The contents of this Addendum alter and amend the drawings and specifications and take precedence over the related items therein. Bidders shall include the cost of all items in their Bids.

LOWER POTTS GROVE TWP
LOWER POTTS GROVE MUNICIPAL
BUILDING & POLICE STATION
1963 E HIGH ST. POTTSTOWN, PA. 19464

CONSTRUCTION DOCUMENTS REVISION HISTORY		
ID	DESCRIPTION	DATE
B00	ISSUED FOR BID/PERMIT	9/3/2024
B01	ADDENDUM 3 REVISIONS	9/20/2024

A-701

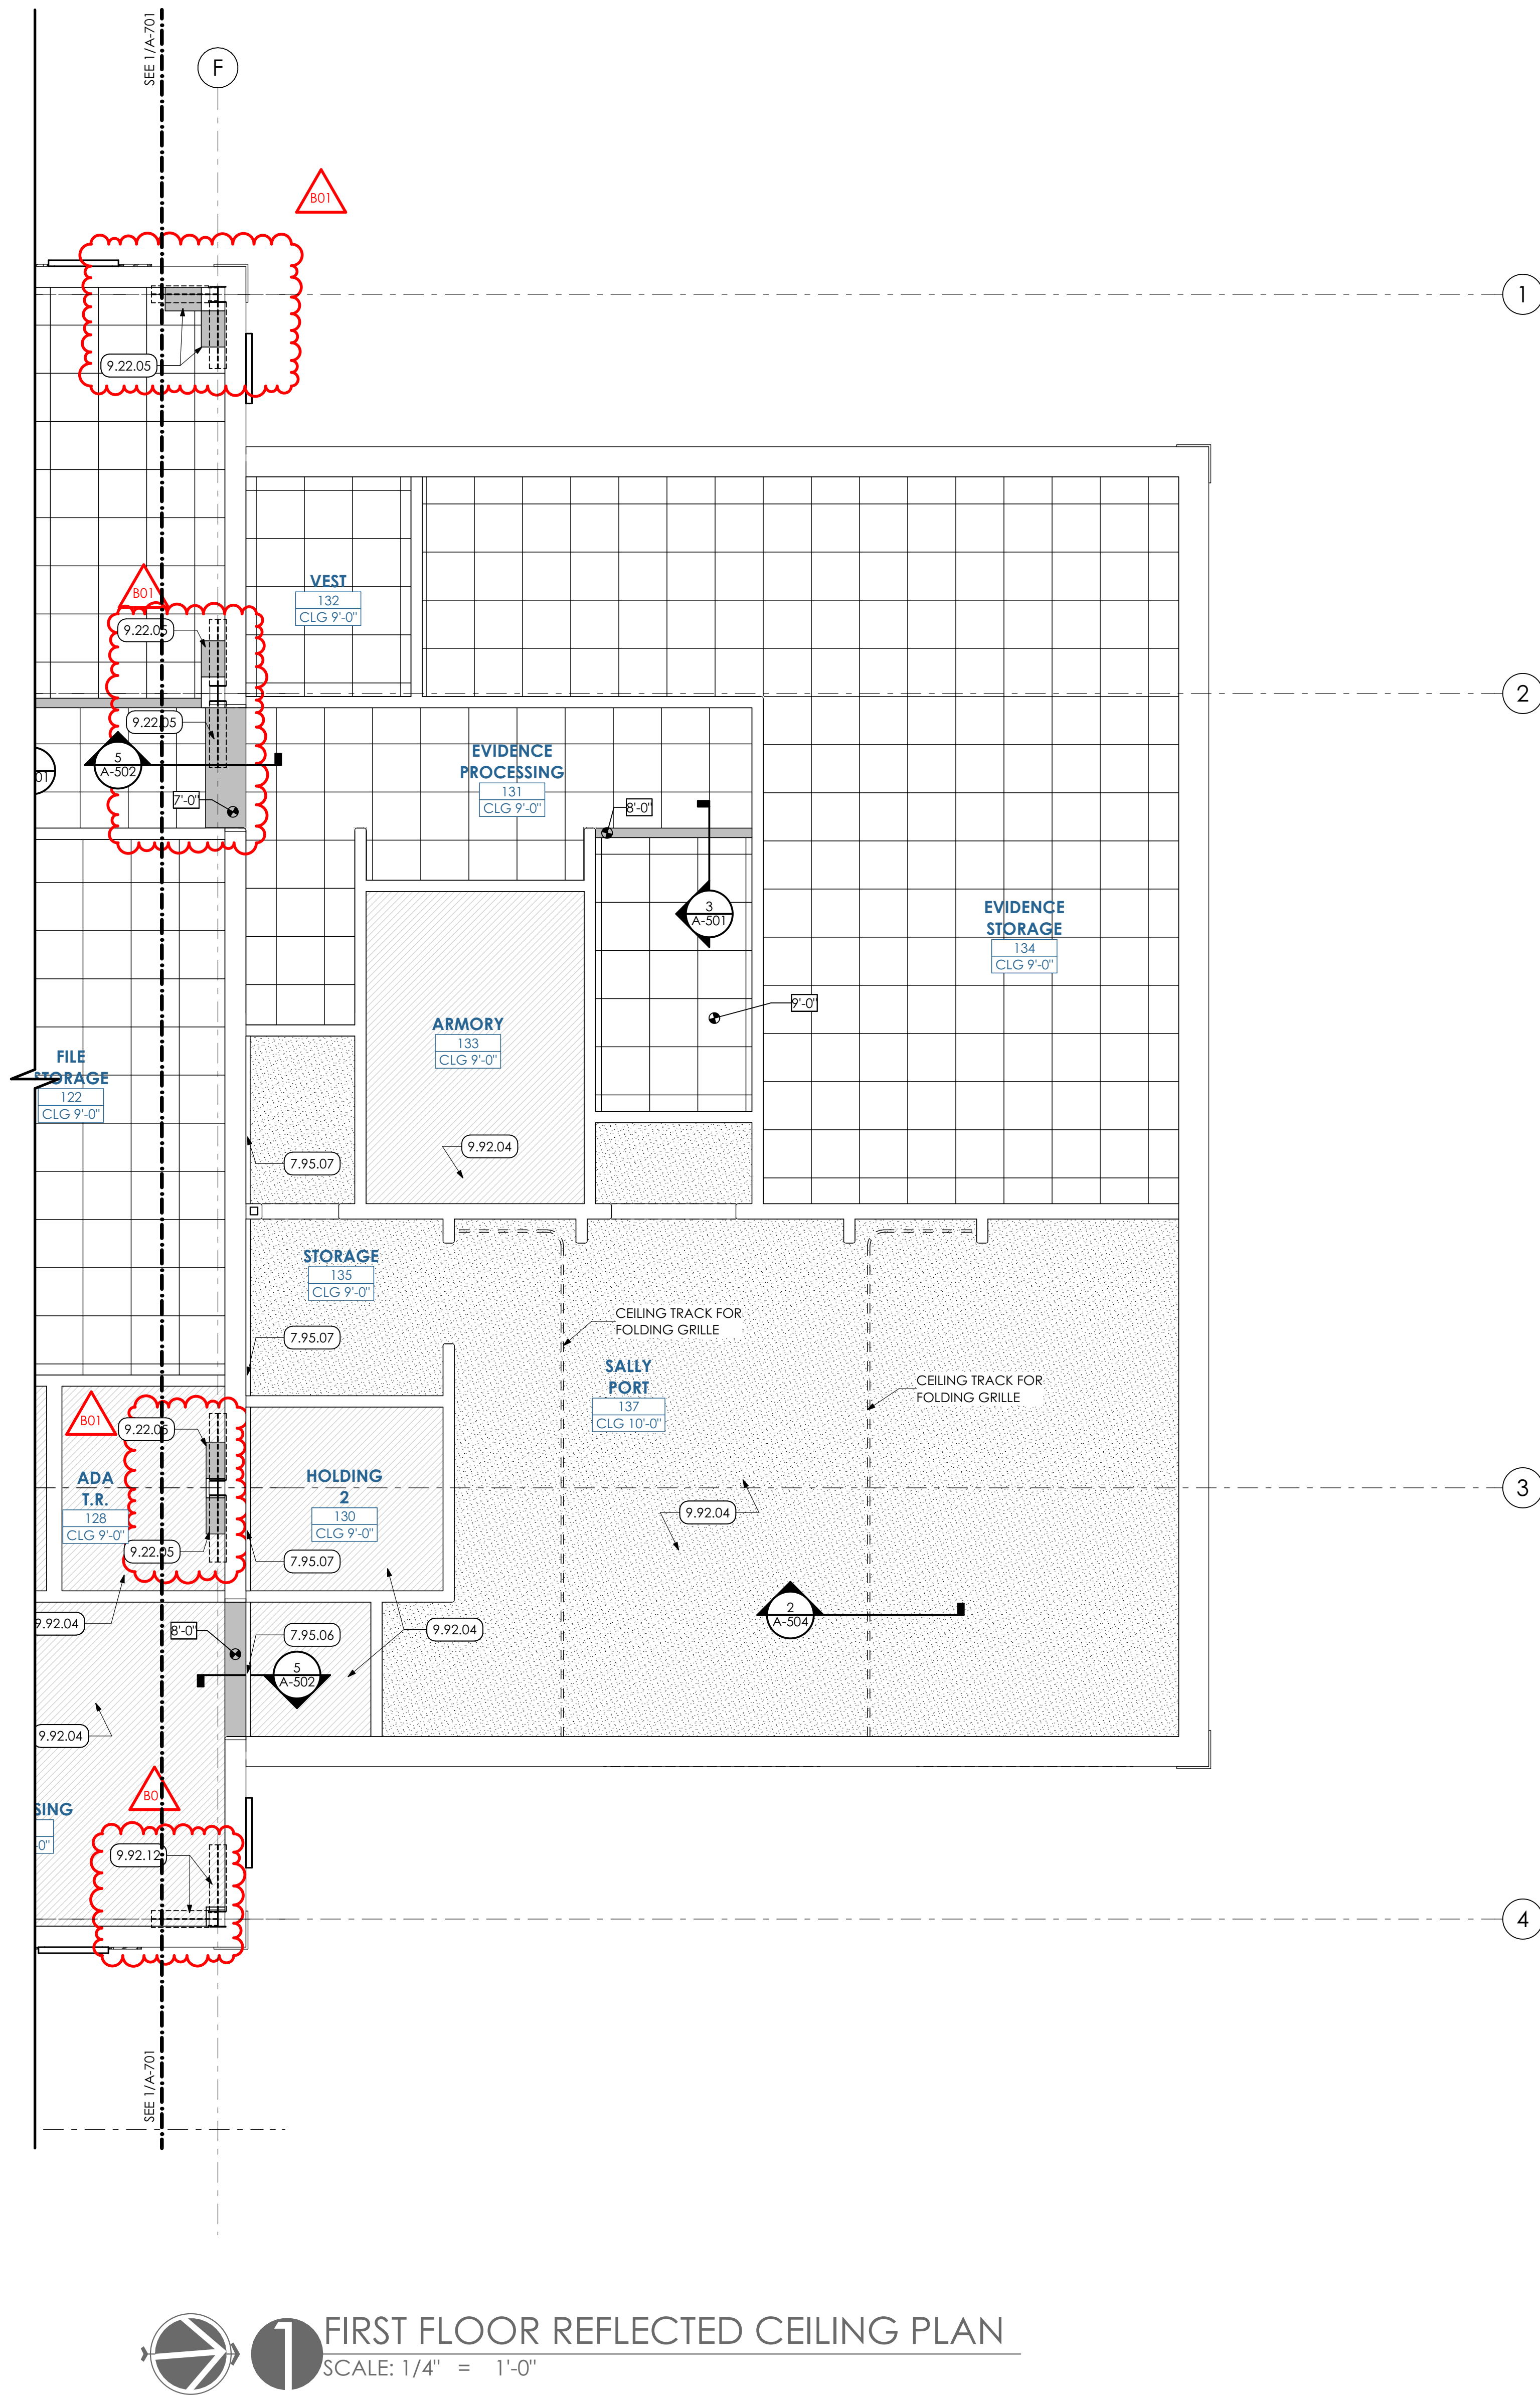
A-701: Soffits added at structural bracing.

7.95.07 INTERIOR ALUMINUM RECESSED CEILING TO WALL EXPANSION JOINT COVER.
- 09 FINISHES**
9.22 NON-STRUCTURAL METAL FRAMING | SPEC 092216
9.22.05 CONSTRUCT ANGLED SOFFIT AROUND NEW KNEE BRACING. SEE DETAIL 9/A-501.

A-703

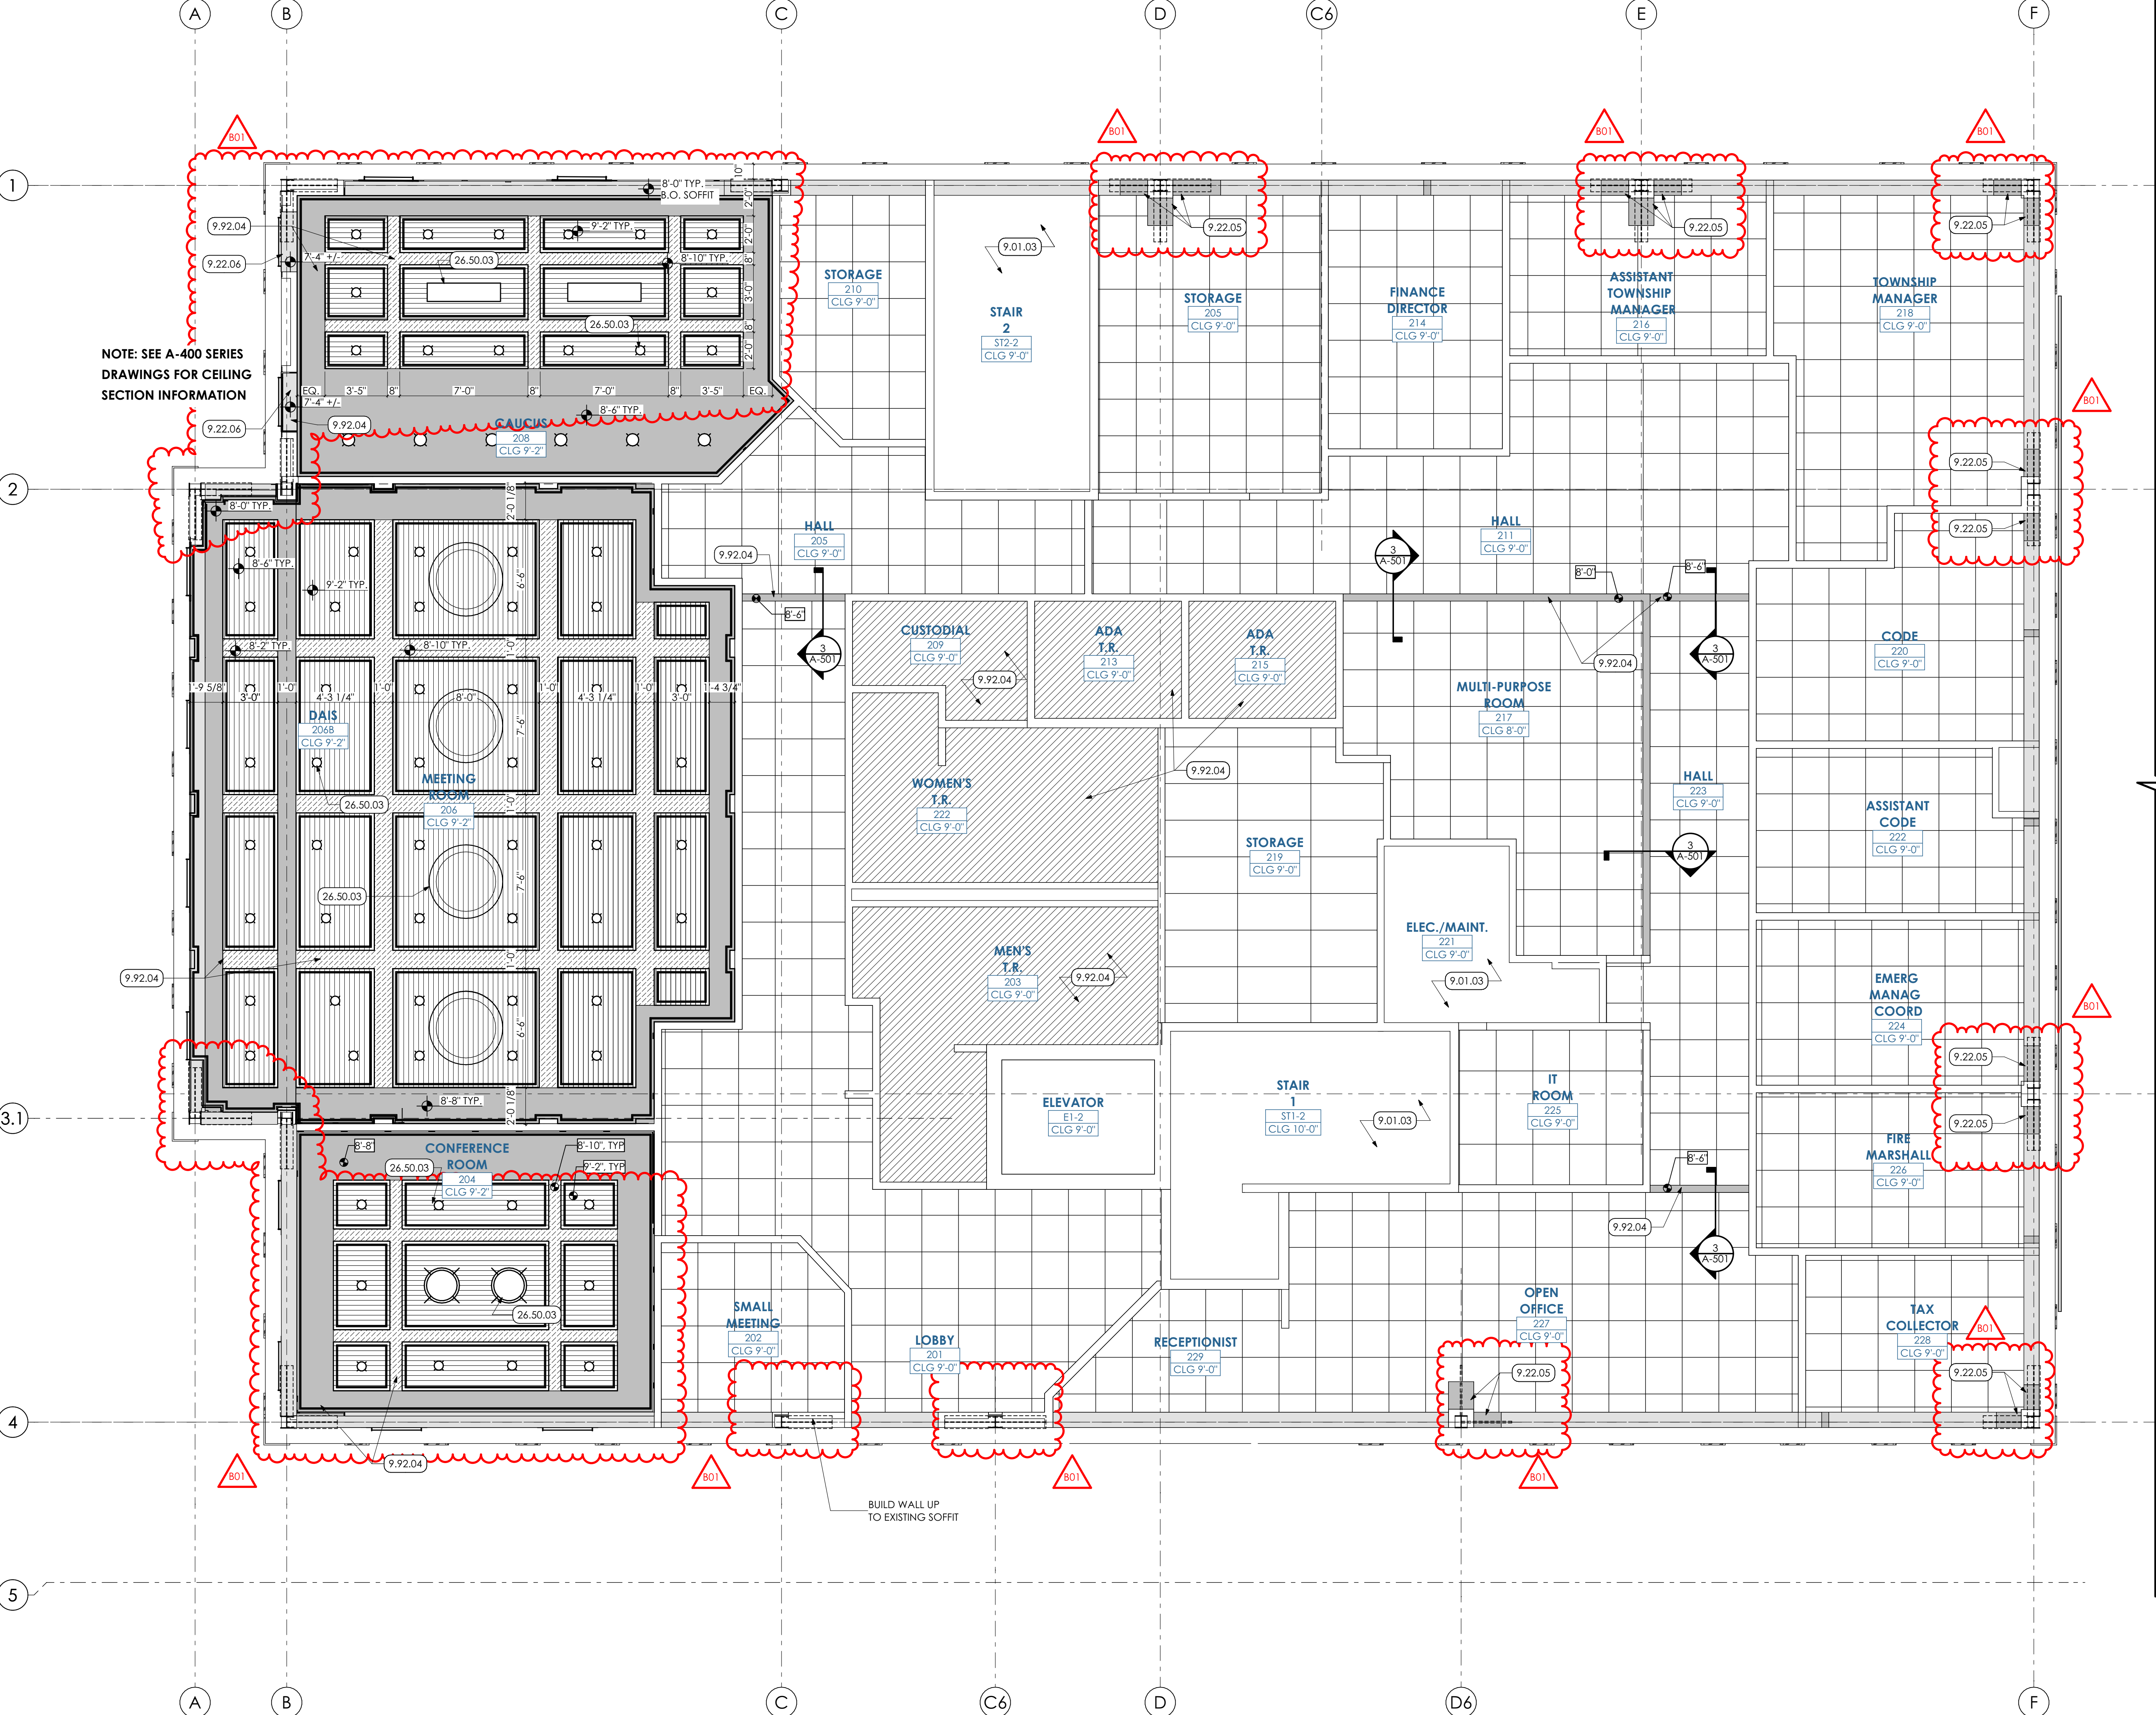
- A-702:** Soffits added at structural bracing.
- A-703:** Soffits added at structural bracing. Meeting room ceilings modified.
- S-101:** Retaining wall and footing information added.
- S-102:** Retaining wall and footing information added.
Header at Evidence Lockers and detail marker added.
- S-301:** Bracing details 9 & 10 clarified.
- S-302:** Retaining wall and footing details added.
- E-4:** Exterior wall pack lighting revised.
- E-5:** Light fixture designation at stair 1 corrected from 'DE' to 'LE.'
- E-7:** General notes 6 and 7 revised.
- E-12:** Lighting schedule corrected for fixture 'AF.'
